RAMP REPORT REGION 2 ADA 2026

Route 7 – Vine Street
Belfast

Merriam Dr. West Side – CR20049

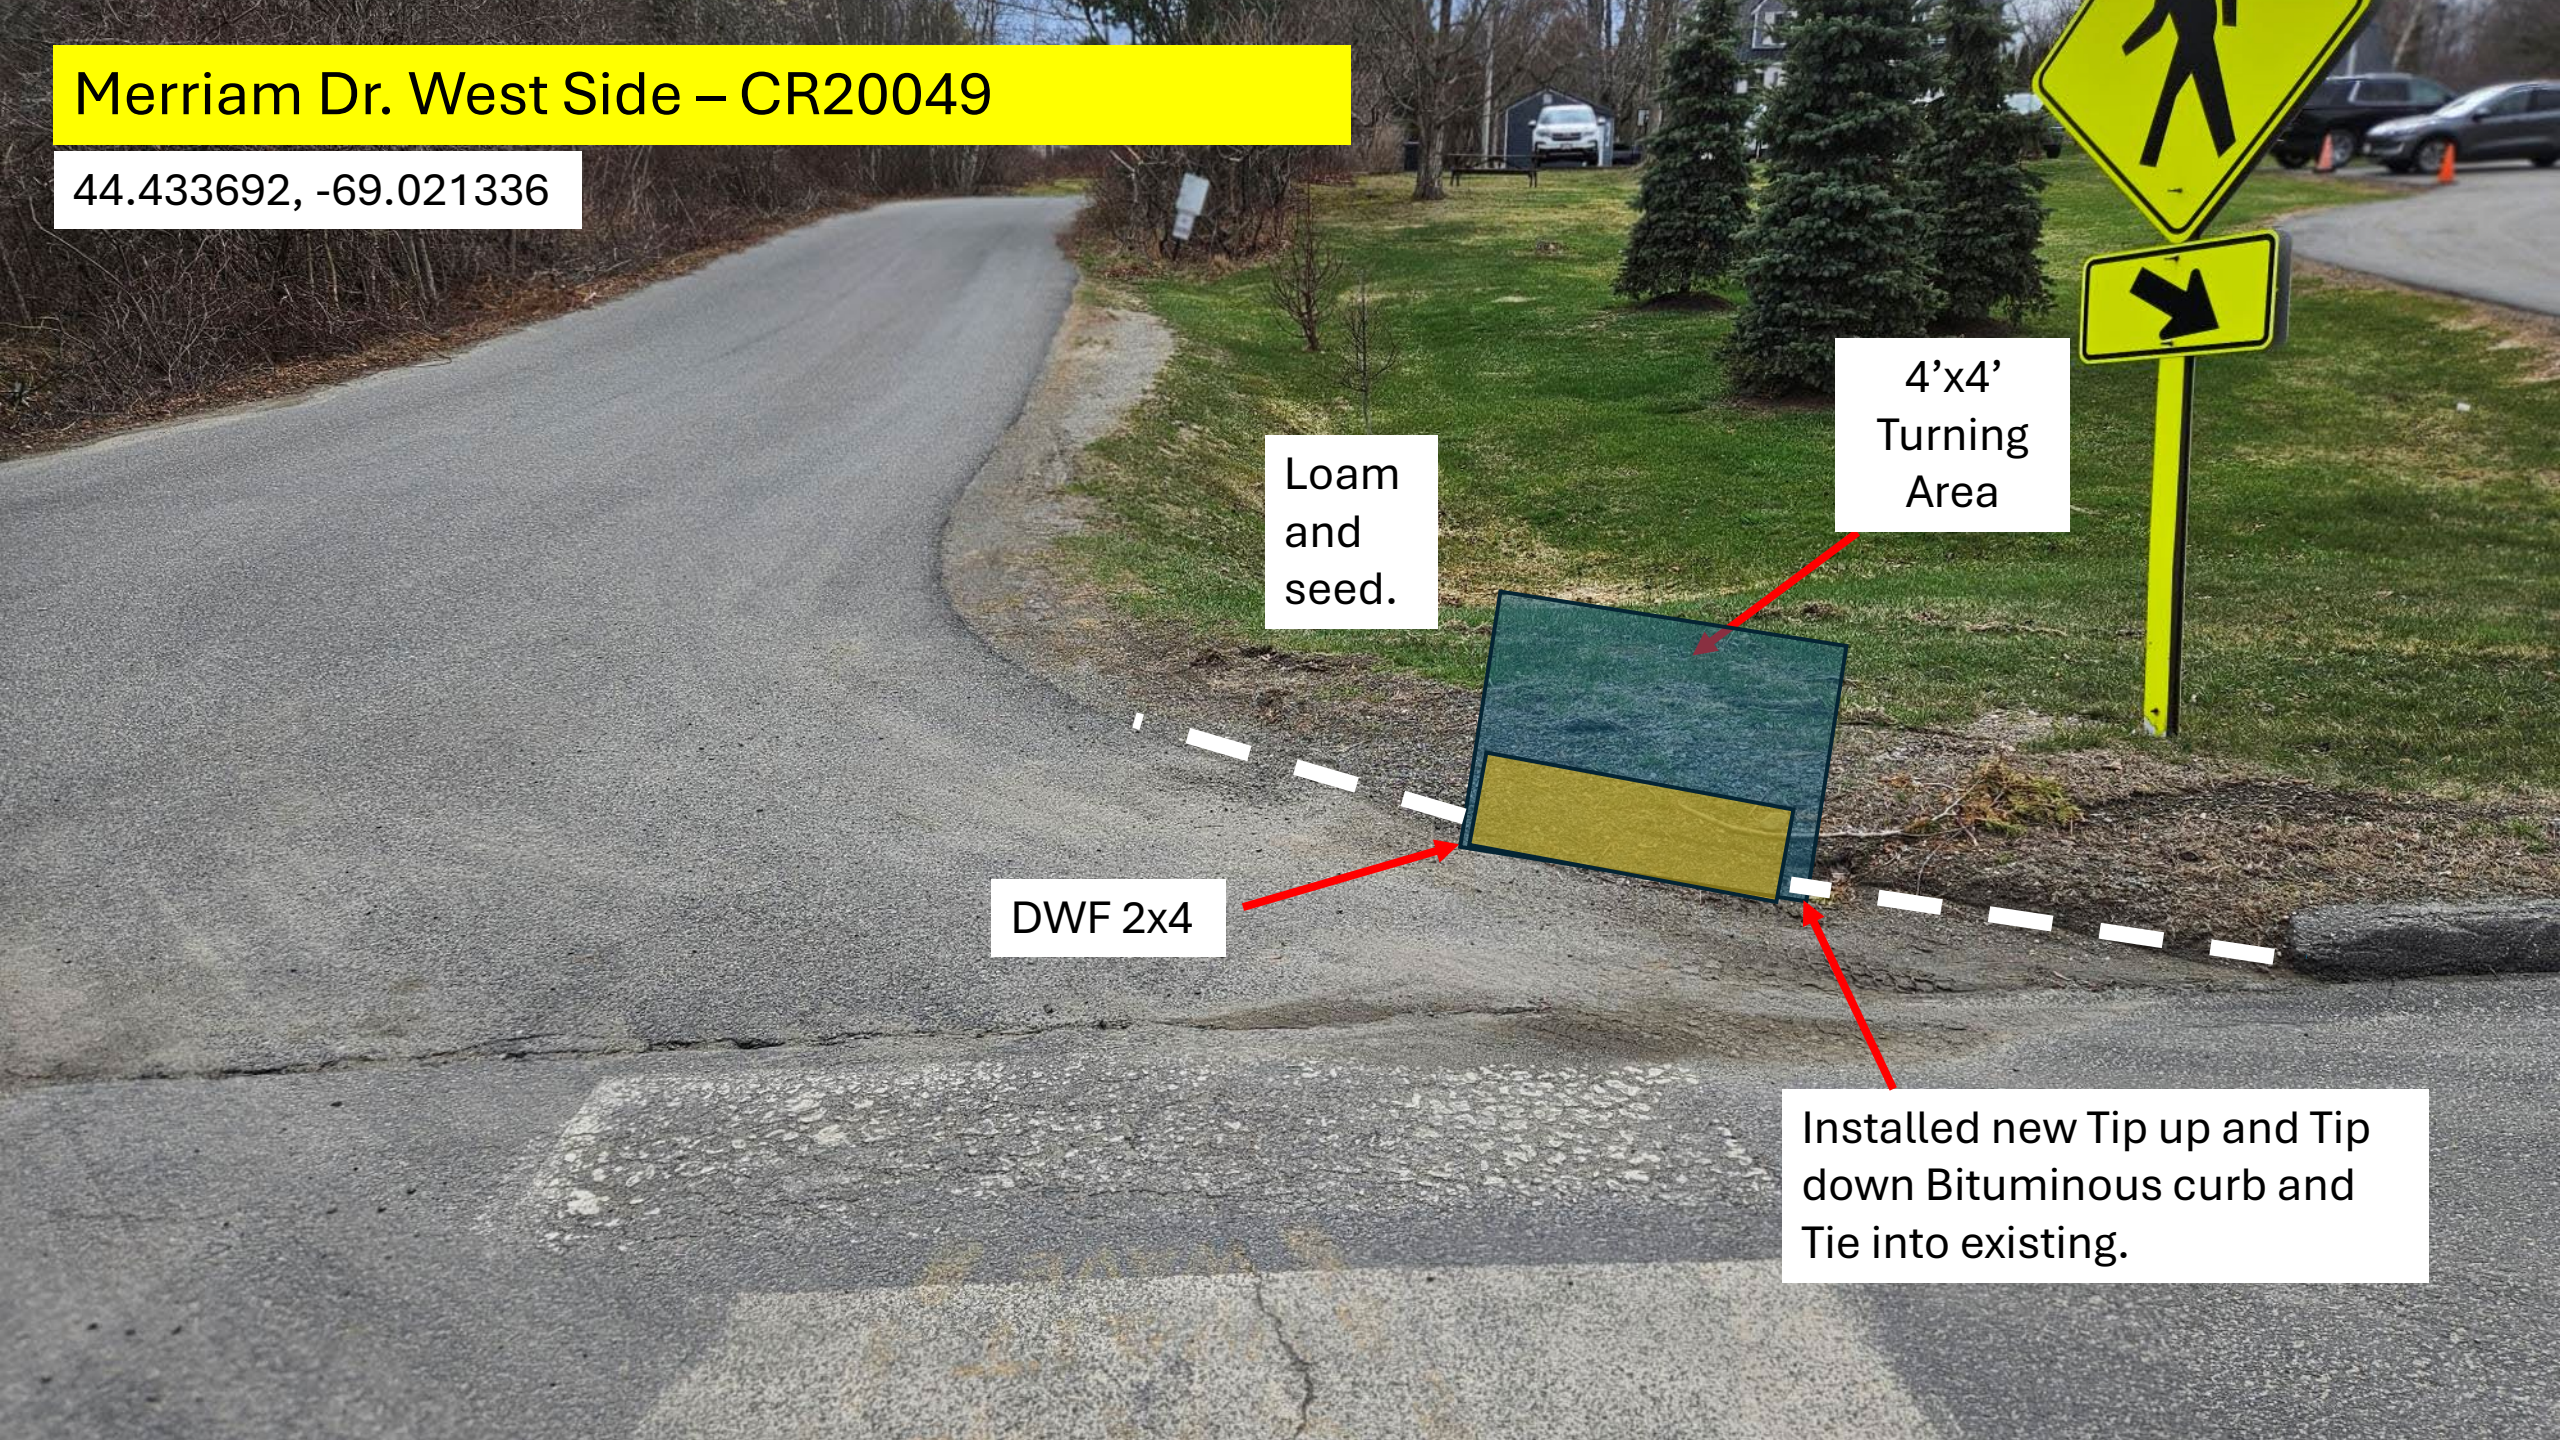
Loam
and
seed.

4'x4'
Turning
Area

DWF 2x4

Installed new Tip up and Tip
down Bituminous curb and
Tie into existing.

CR09386

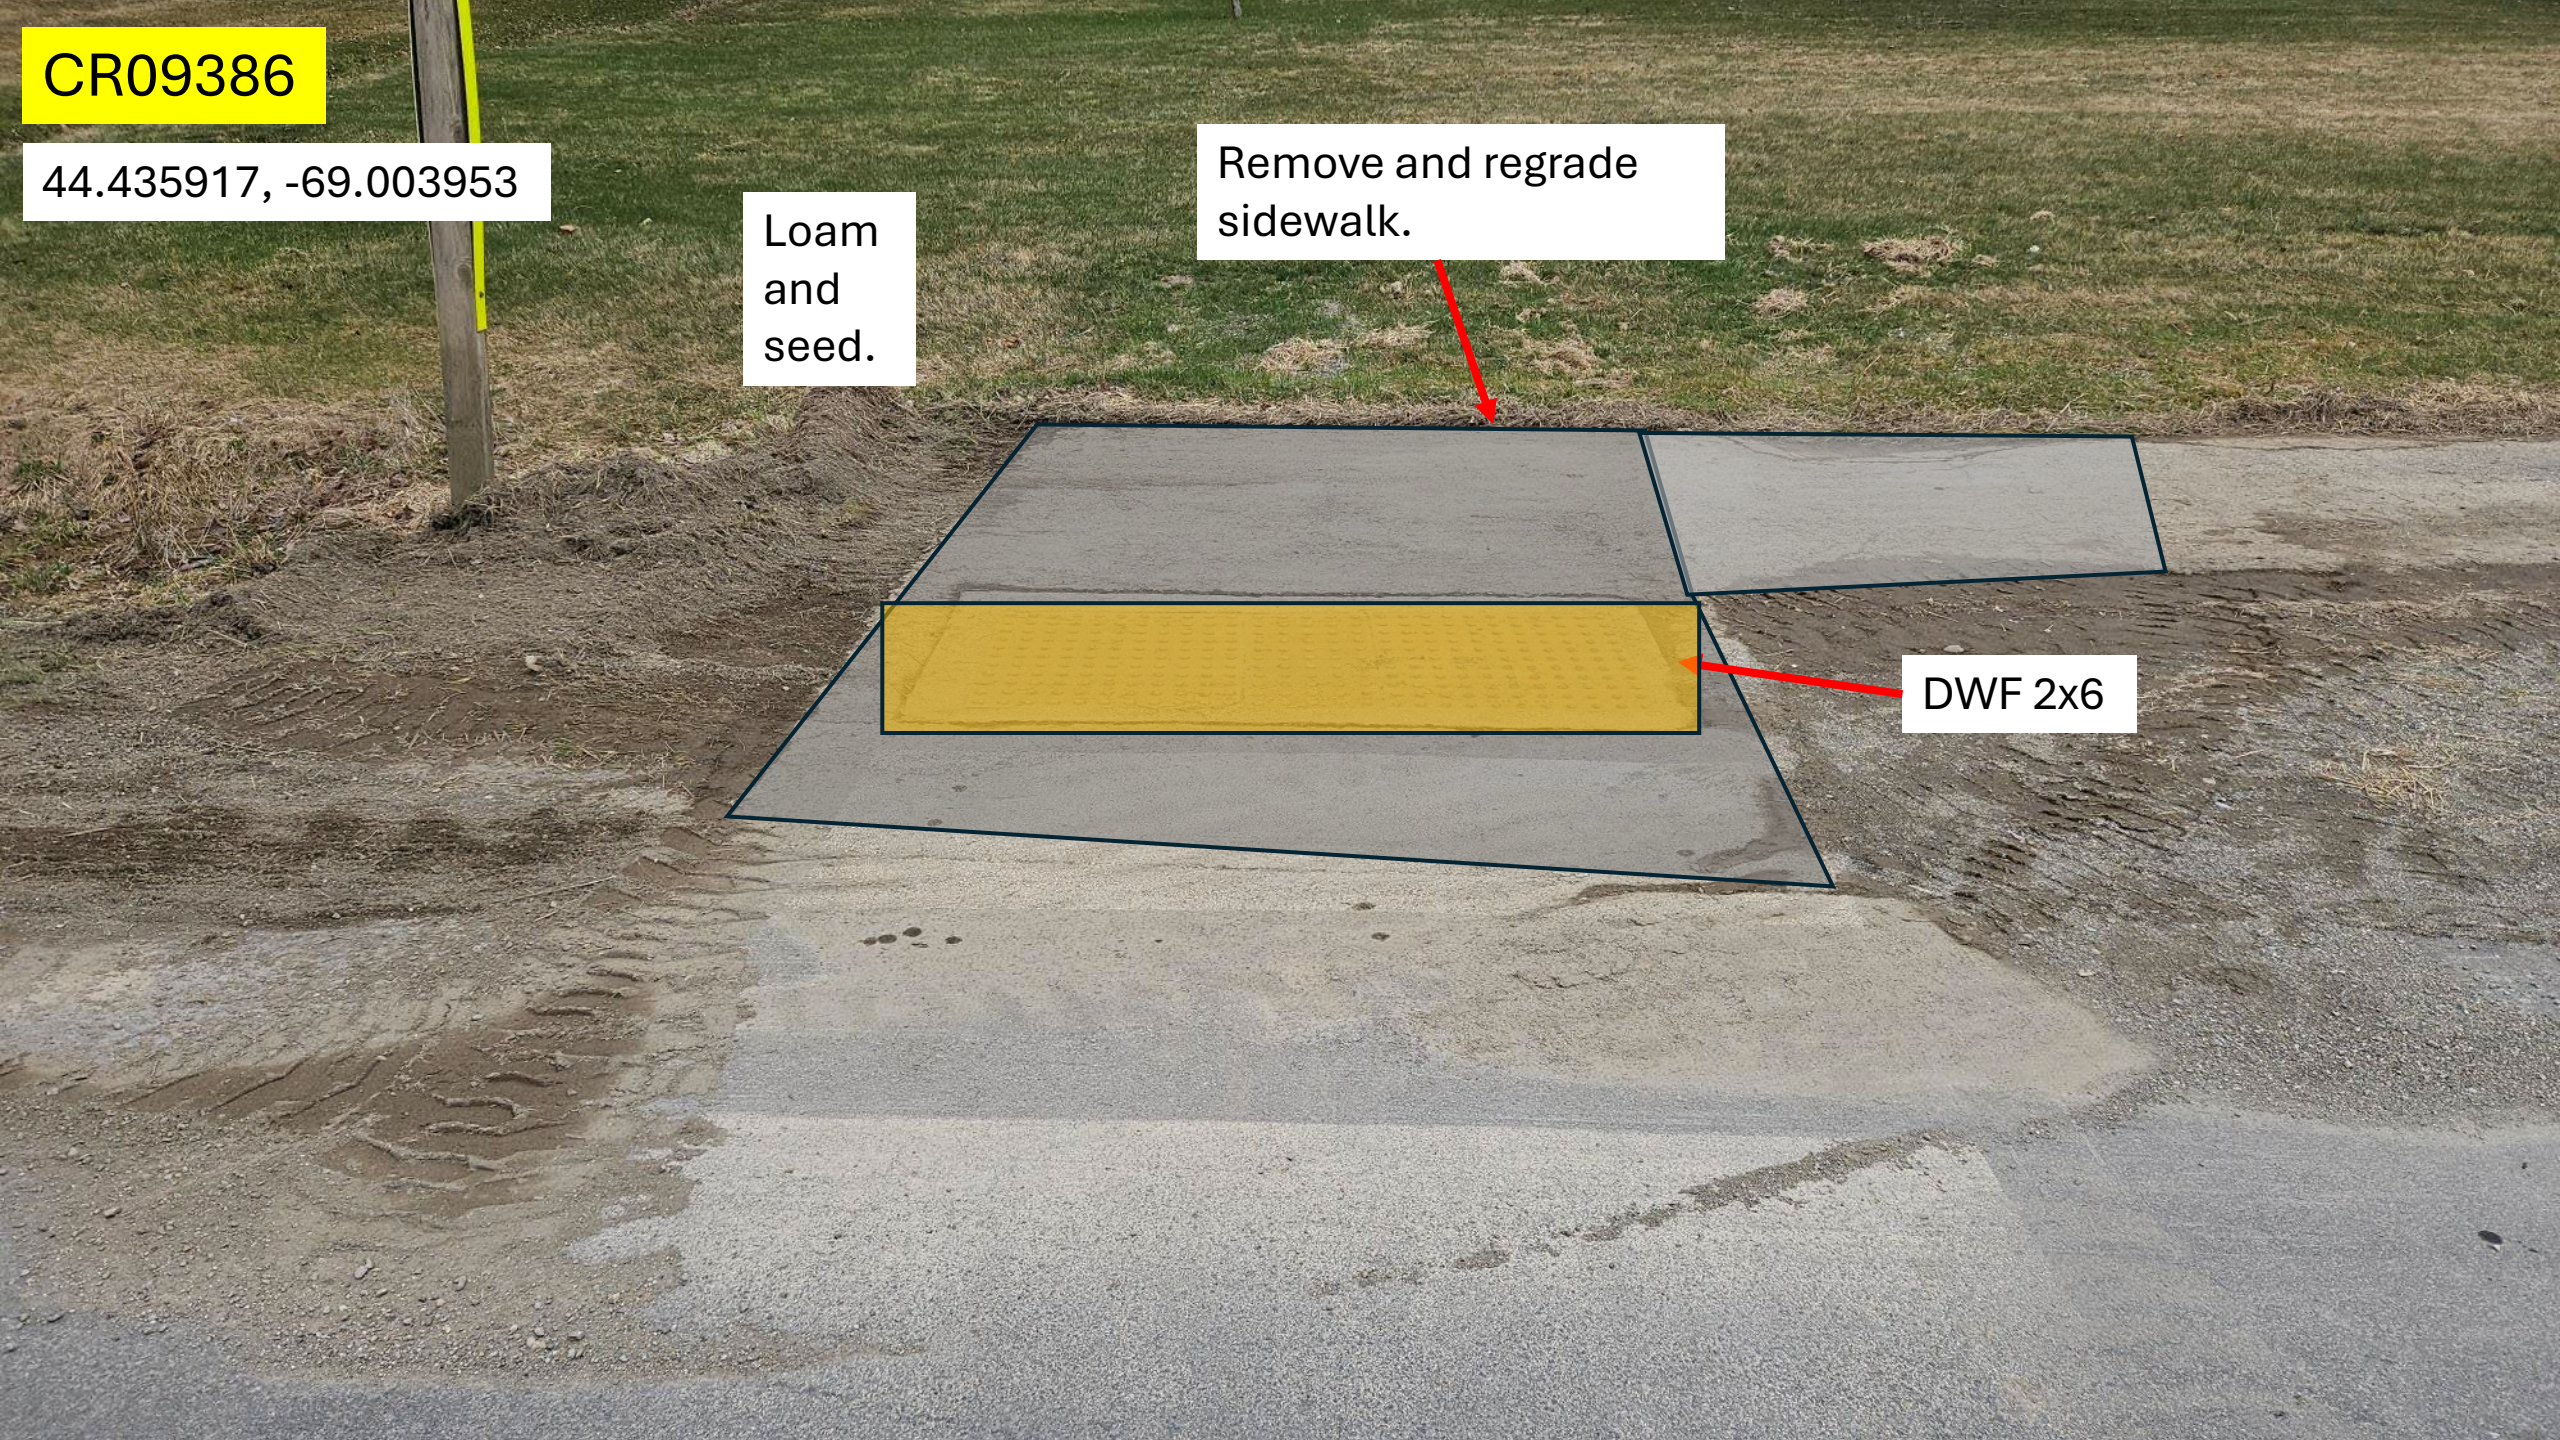
Loam
and
seed.

Remove and regrade
sidewalk.

DWF 2x6
